Summit County Planning Commission (SCPC)

Planning Commission Final Plat **Ridge Drive** Copley Township

Weber Engineering Services Response to Review Comments Dated June 07, 2023

THE RIDGE TOWNHOMES SITE DEVELOPMENT COPLEY TOWNSHIP, OHIO

C103(
Project No. 2022-2)

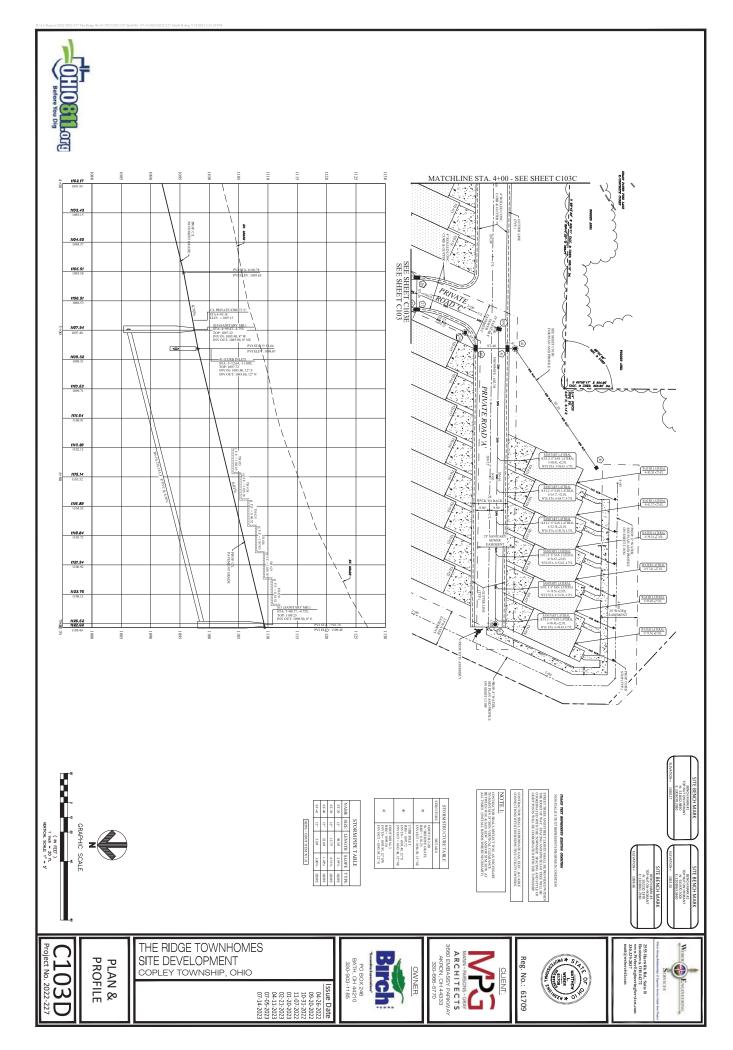
18. On Sheets C103 – C103B, the minimum R/W and Pavement Width for a Local Commercial and Industrial Street is 60' and 30', respectively. In addition, the maximum profile grade is 6%. The plans will need to be revised accordingly.

- 19. On Sheets C103-C103C, the 25 Year HGL must be shown in the profiles. Revised as requested.
- 20. On Sheet C103, for the proposed Low Point at Sta. 1+11.71, add a Vertical Curve, Low Point Sta. and Elevation, Drainage Tangent, etc... that is in conformance with the ODOT Cross Road Profile in the L & D Manual, Volume 1 Figure 401-2. In addition, the maximum profile grade within 60' of the intersection is 5%.

21. On Sheet C103, for the proposed Low Point at Sta. 1+11.71, the street must maintain it's designed cross slope and the pavement drainage must be routed to the Curb and Gutter. Existing Structure #1 cannot be utilized as a substitute for providing ODOT No. 3 CB's (Double) in the Curb and Gutter at the location of the Low Point. In addition, the entire pavement area must be captured and routed to the Retention Basin and released undetained. From the location of the Low Point, there must be a 100-Year Overland Flow Path to the Retention Basin (See Comment #8).

- 22. On Sheet C103, Existing Structure #1 should be replaced with a Manhole.

24. On Sheet C103, add the following notes:

'A full depth pavement sawcut and butt joint in conformance with current ODOT Standard Construction Drawing BP-3.1 is required at the intersection of Rothrock Road and Ridge Drive.'

25. On Sheet C103, identify the Station, Offset and OMUTCD Sign Reference Number for the proposed Stop Sign at Rothrock Road and Ridge Drive.

Revised as requested.

Revised as requested per comment and 06/23 phone correspondence.

Existing structure #1 revised as a manhole per comment no. 22. Design cross slope maintained to maximum degree as transition to Rothrock Rd. existing longitudinal slope takes place. Only 0.01 acres of drainage is received by proposed curb inlet no. 34 as discussed to be reasonable in our 06/23 phone correspondence.

Revised as requested.
- 23. On Sheet C103, identify the proposed ODOT Curb Ramp Types located near Rothrock Road and update the Standard Drawings located on Sheet C105C. Also, add Curb Ramps Mid-Block of the entire street and at the cul-de-sac.

Revised as requested.

Revised as requested.

C103G
Project No. 2022-227

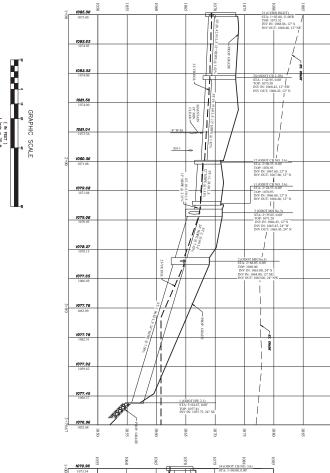
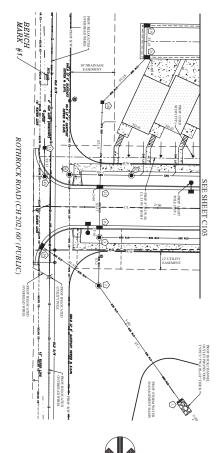
28. On Sheet C104, the slope at the outfall of the emergency spillway should be evaluated for Rock Channel Protection (See the Shear Stress Equation and Table on Page 65 of the Current Edition of the SCE Stormwater Drainage Manual and apply the appropriate controls for the 100 Year Undetained Flow). In addition, provide a capacity calculation which verifies the proposed emergency spillway can accommodate the 100 Year Undetained Flow.

Calculations added to stormwater management report as requested. Emergency spillway rock channel protection identified on sheet C103G.

C105A

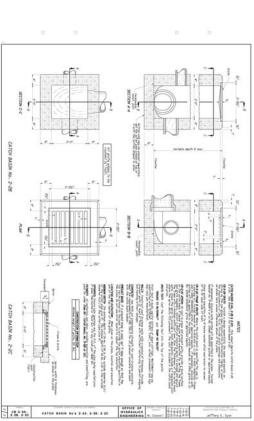
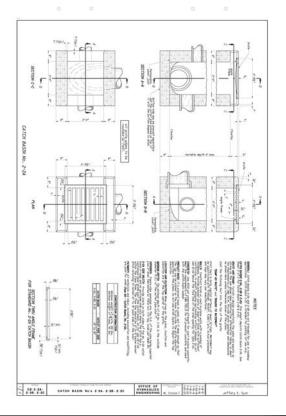
38. On Sheet C105A, update the ODOT Standard Drawing for CB's 2-2A, 2-2B and 2-2C and the SCE Trench Detail. Also, delete the Summit County Pavement Replacement Detail. There will not be any open cuts permitted on Rothrock Road and all utility crossings must be bored.

39. On Sheet C105A, update the ODOT Standard Drawing for CB No. 3A and add the ODOT Standard Drawing for CB No. 3 and Monument Assembly (RM-1.1).

Revised as requested.

Updated/added on sheets C105B and C105F.
